MANATEE COUNTY

SUBJECT: Invitation for Bid #12-1310-OV
SWWRF Lake Filtration System and North Pond Improvements
Bradenton, FL, Manatee County Project No.: 6079180

ADDENDUM #4

Attached memorandum dated June 4, 2012 from McKim & Creed is issued to respond to questions received from Contractors at the Pre-Bid / Information Conference held on April 30, 2012 and questions received via email from Contractors. (14 Total Pages)

ADDENDA - UFPS PIPE SUPPORT INFORMATION

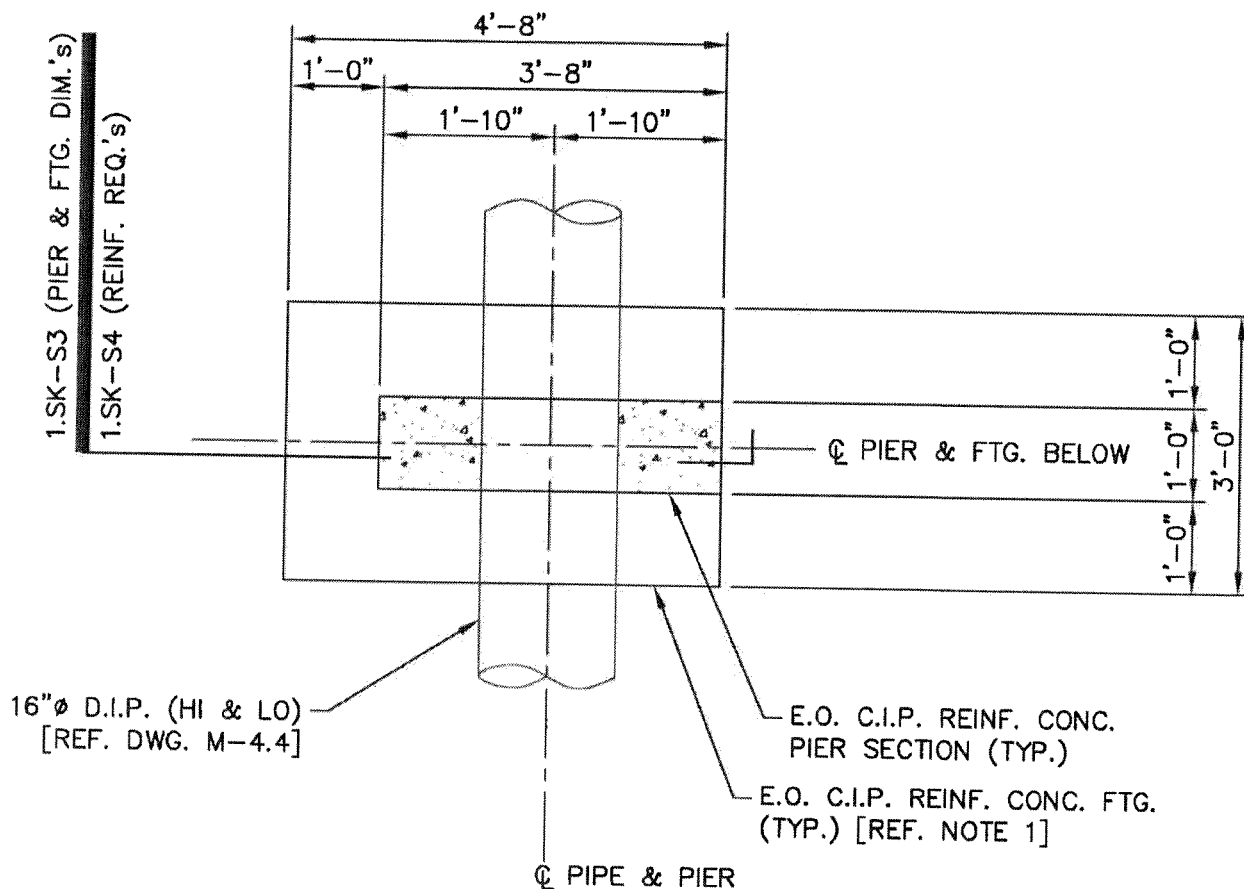
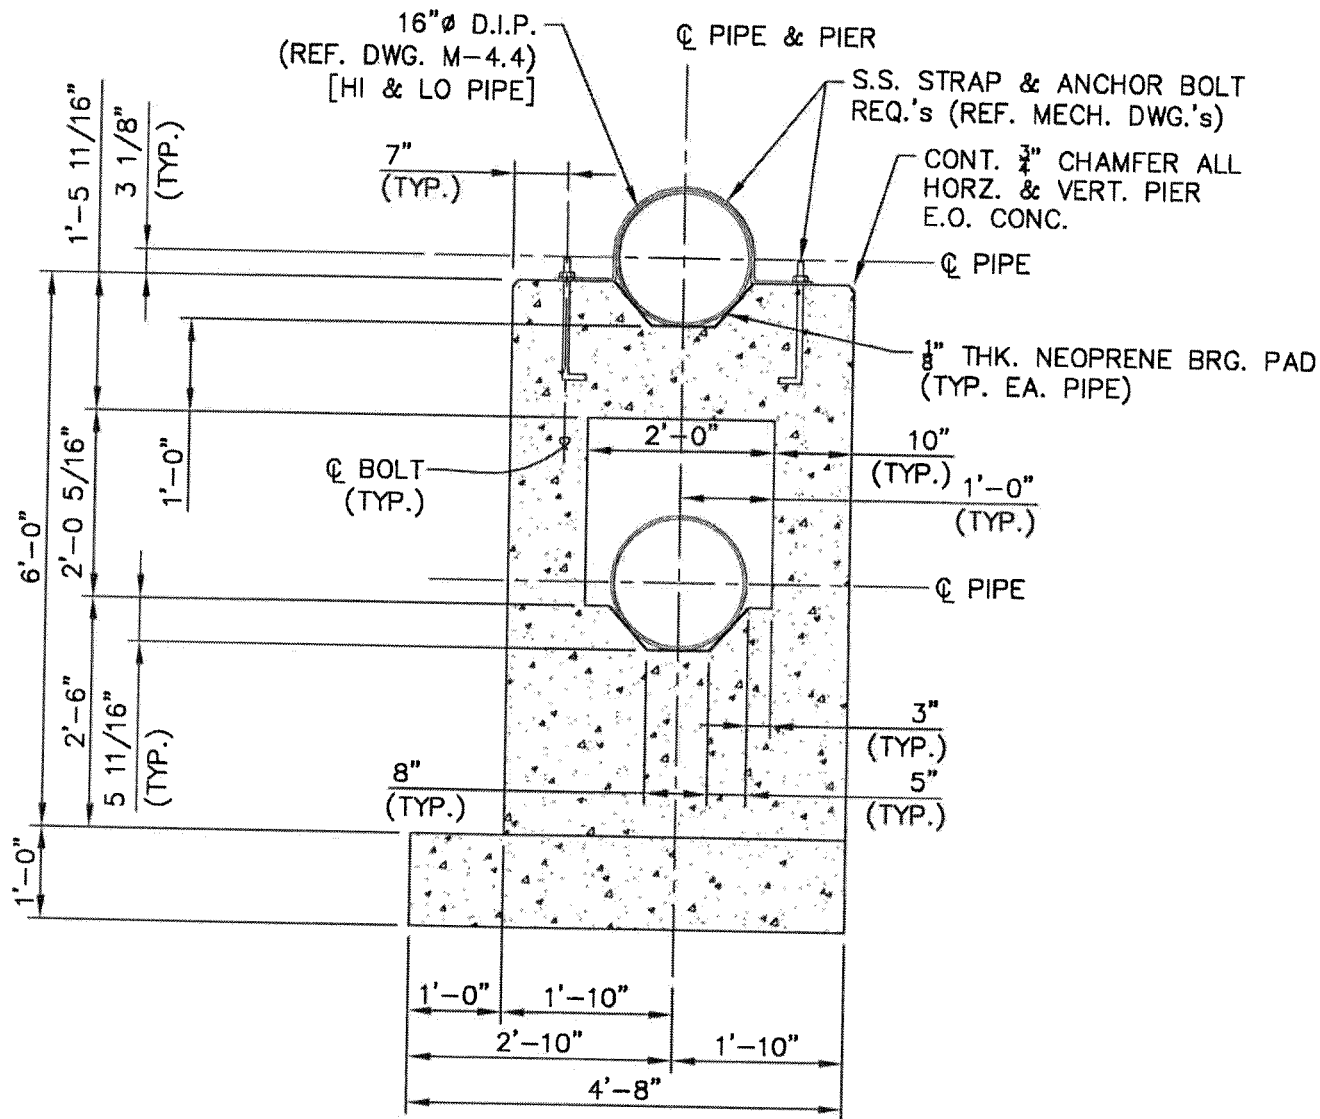
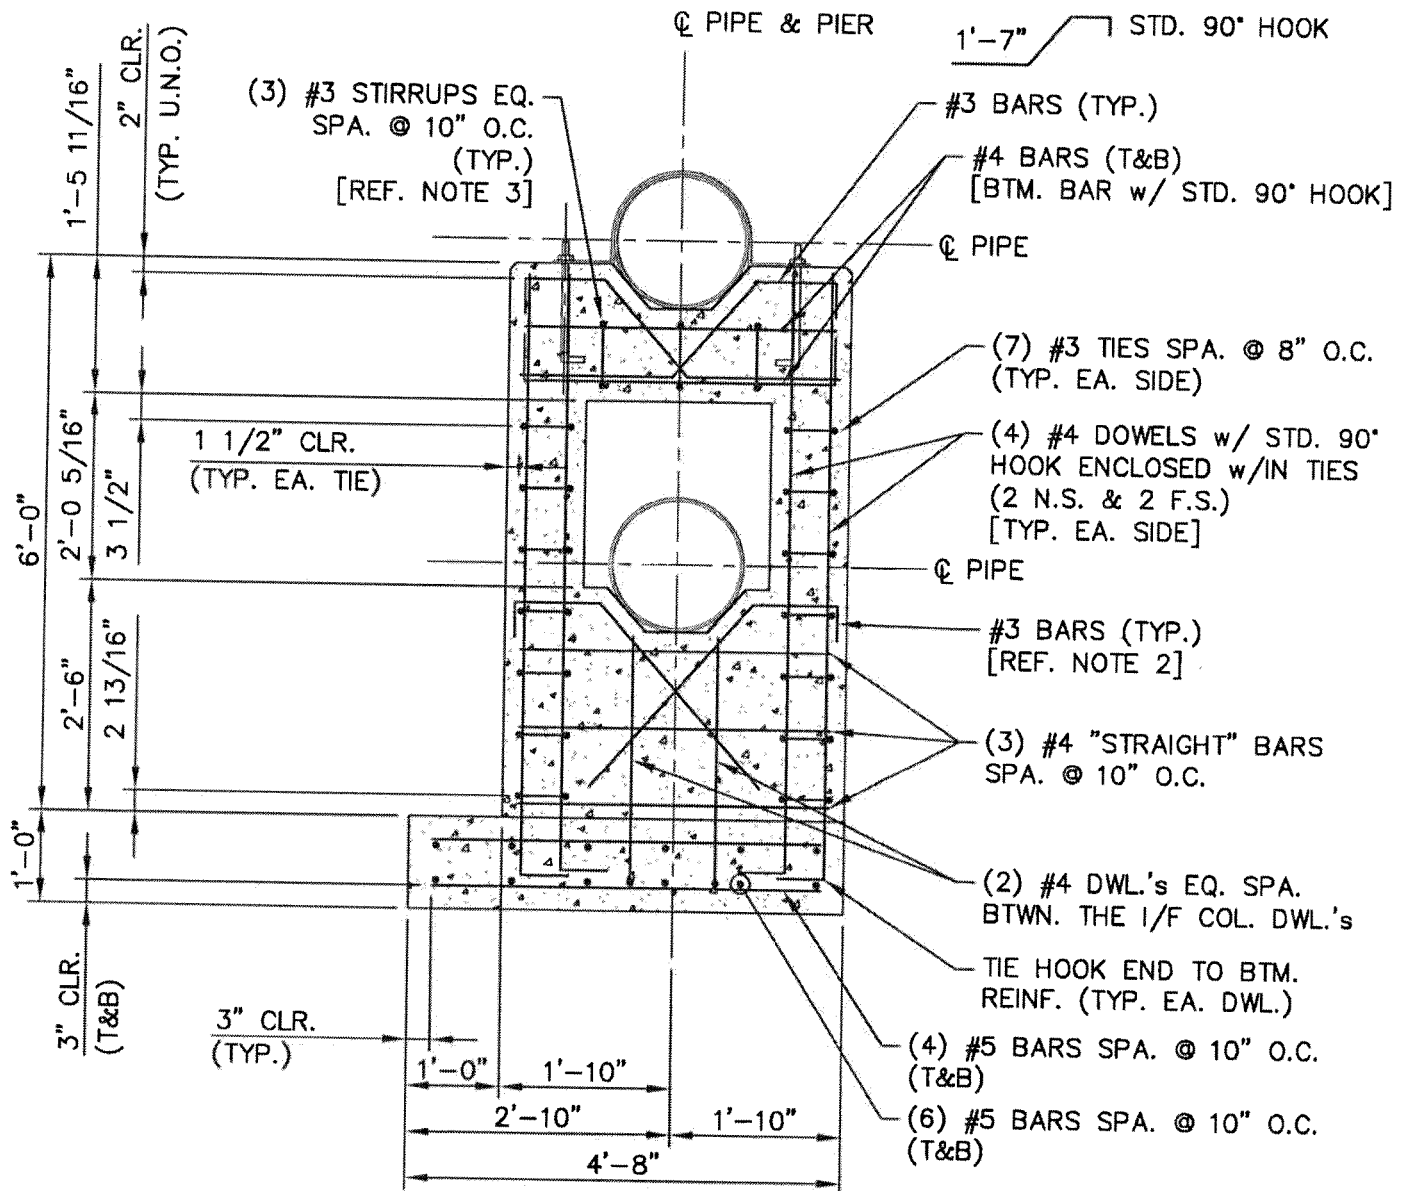
1. Revised Sheet C-0.2, Revision 1 – Proposed Site Plan and Soil Erosion and Sedimentation Control.
2. Revised Sheet C-0.14, Revision 1 – Yard Piping No. 1.
3. Revised Sheet C-1.0, Revision 1 – Overall Grading Plan and Key Sheet
4. Revised Sheet C-1.18, Revision 1 – Pond Sections No. 6
5. Sheet M-5, Middle Pond Control Structure Plan and Sections
Dated 3/18/02
6. SWWF Lake Filtration & North Pond Improvements – Staging Areas
7. Pond Fill Excavation Location – Figure 1
8. Revised M-4.4, Revision 1 – Unfiltered Pump Station
9. SK-S1 through SK-S4 dated 05/16/2012, Addenda UFPS Pipe Support Information

- PIER SECTION VERT. & HORZ. BARS ARE N.S. & F.S. U.N.O..
- #3 BAR ASSEMBLY SIMILAR TO #3 BAR FOR "HI" PIPE EXCEPT DIAGONAL LEG LENGTH 2'-7" (MIN.).
- PROVIDE 1 1/2" CLR. DISTANCE ON SIDE LEG OF STIRRUPS. STIRRUPS TO ENCLOSE THE #4 "STRAIGHT" TOP BARS, THE #4 BOTTOM BARS & THE STRAIGHT LEG OF THE #3 DIAGONAL BARS.
- REFERENCE SK-S1 & SK-S2 FOR ADDITIONAL NOTES & INFORMATION.
